SERVICE INSTRUCTIONS

No. 1250
ATA Code 53-10

SUBJECT: FUSELAGE - INSTALLATION OF IMPROVED CABIN ENTRANCE STEPS.

EFFECTIVITY: BEECHCRAFT Skipper 77, serials WA-1 through WA-312.

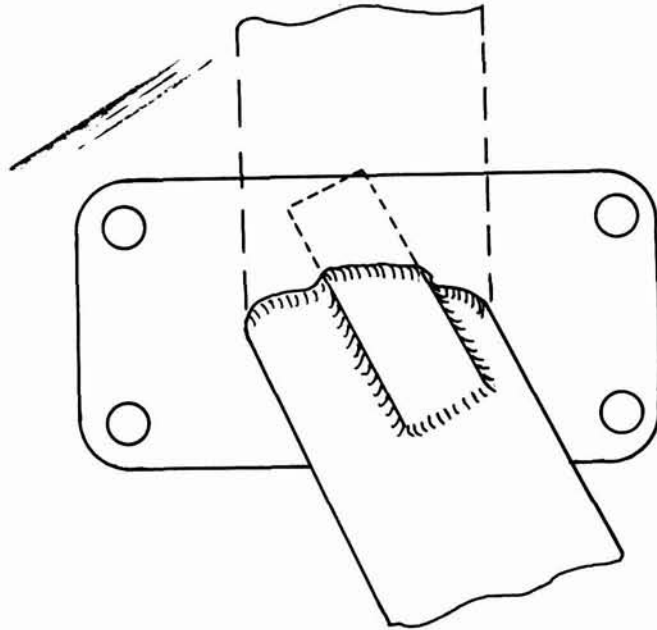
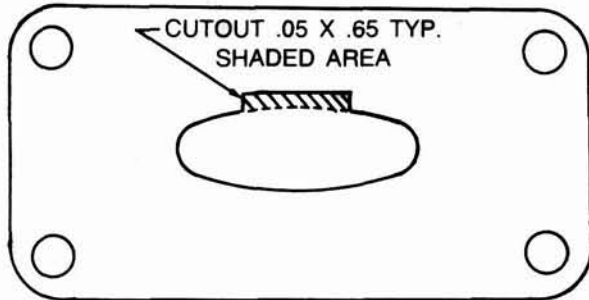
3. Insert the new assist step into the fuselage as far as possible and, using a marker, determine the amount of fuselage skin to be trimmed to facilitate installation of a new assist step. See illustrations.

4. Remove only enough material from the fuselage skin to provide adequate clearance so that, once the step is

installed, there is no evidence of chafing between the step and the fuselage. Apply zinc chromate primer (obtain locally) to the area where the fuselage material was removed.
